1981 Corvette: Service Bulletin: Glow Around Wiper Switch Rework Wiper Switch Bezel

Subject: GLOW AROUND WIPER SWITCH REWORK WIPER SWITCH BEZEL

Model and Year: 1981 Corvette

Bulletin Number: 81-I-19

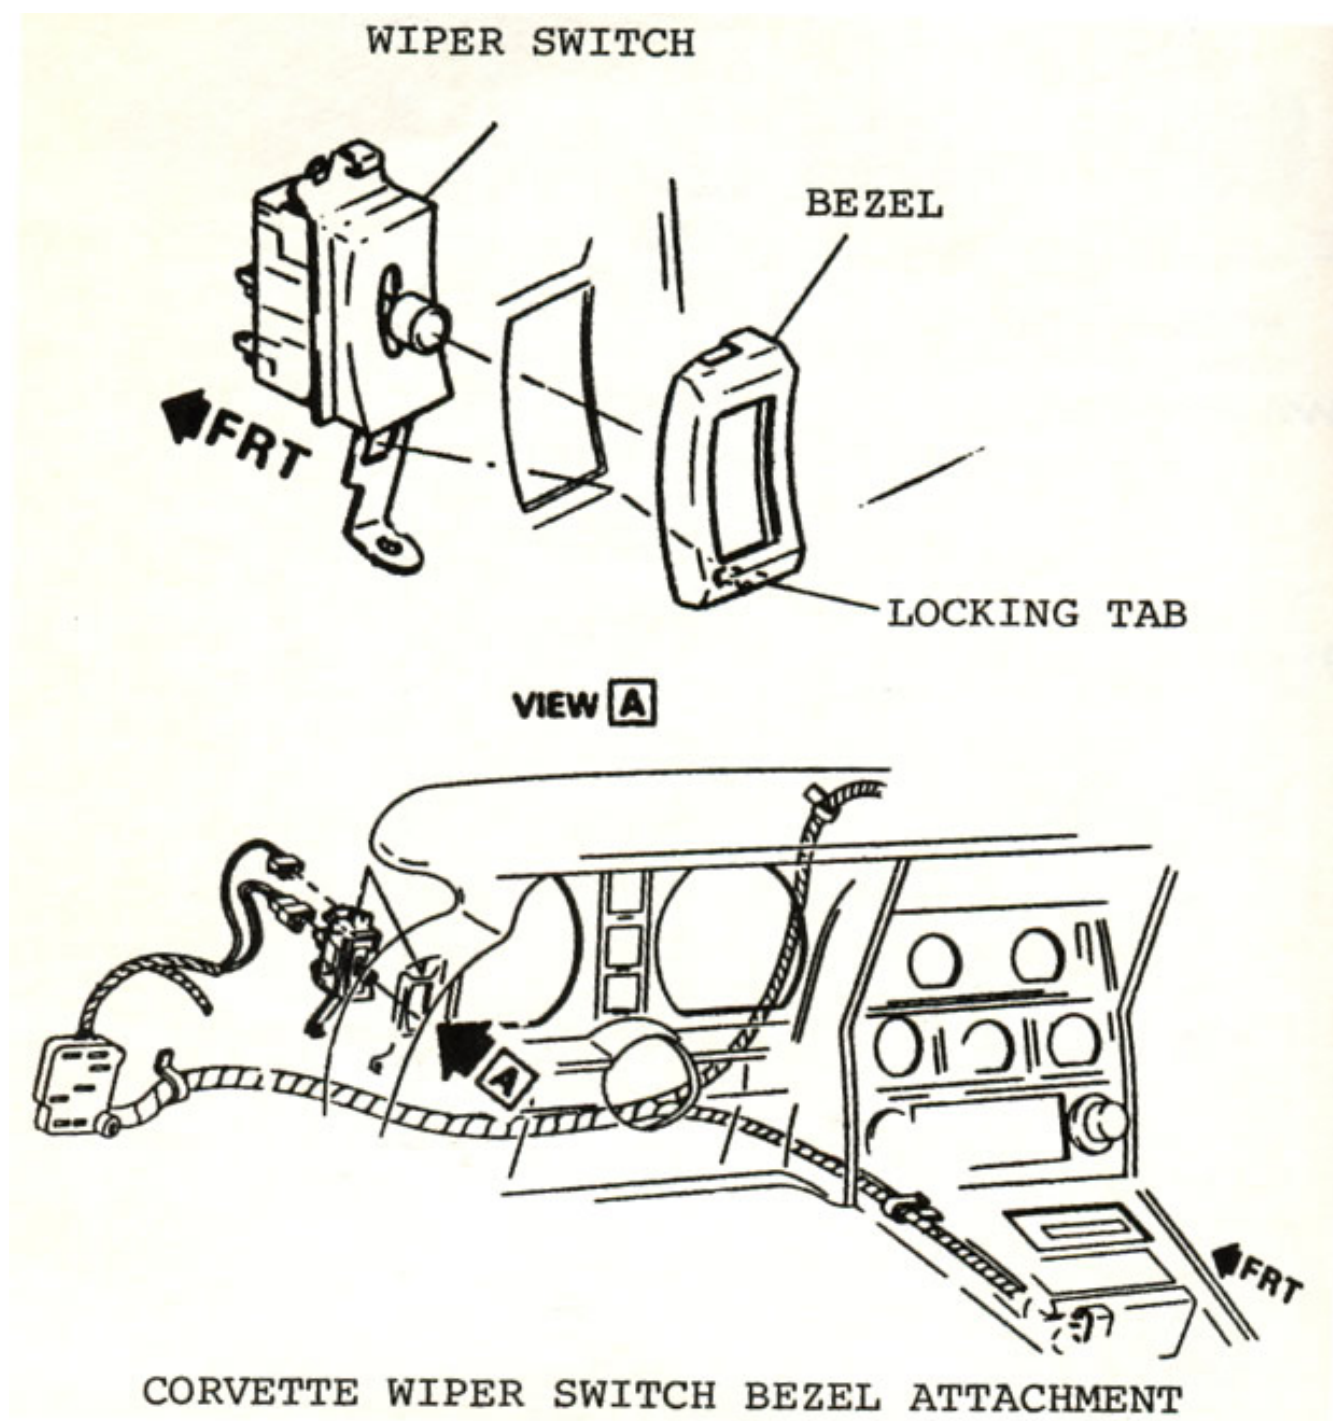
SOME EARLY 1981 CORVETTES WITH SILVER, RED, OR RUST TRIM MAY EXHIBIT A GLOW AT NIGHT AROUND THE WIPER SWITCH BEZEL. IN THESE COLORS, THE BEZEL BASE MATERIAL IS "NATURAL" AND COULD BECOME TRANSLUCENT WITH LIGHTS TURNED ON. THE REMAINING BEZEL COLORS WERE PAINTED OVER A BLACK BASE MATERIAL AND ARE NOT AFFECTED.

THE GLOWING CONDITION CAN BE ELIMINATED BY REPLACING THE ORIGINAL BEZEL WITH P/N 14016216, WHICH IS BLACK AND MUST BE PAINTED TO MATCH TRIM COLOR. THE BEZEL HAS A LOCKING TAB WHICH ENGAGES THE WIPER SWITCH AS ILLUSTRATED ON PAGE 2.

REPLACEMENT REQUIRES SETTING THE STEERING COLUMN TO ITS LOWEST TILT POSITION, REMOVING THE SPEEDOMETER CLUSTER, AND REACHING THROUGH THE INSTRUMENT PANEL TO DISCONNECT THE BEZEL LOCKING TAB.
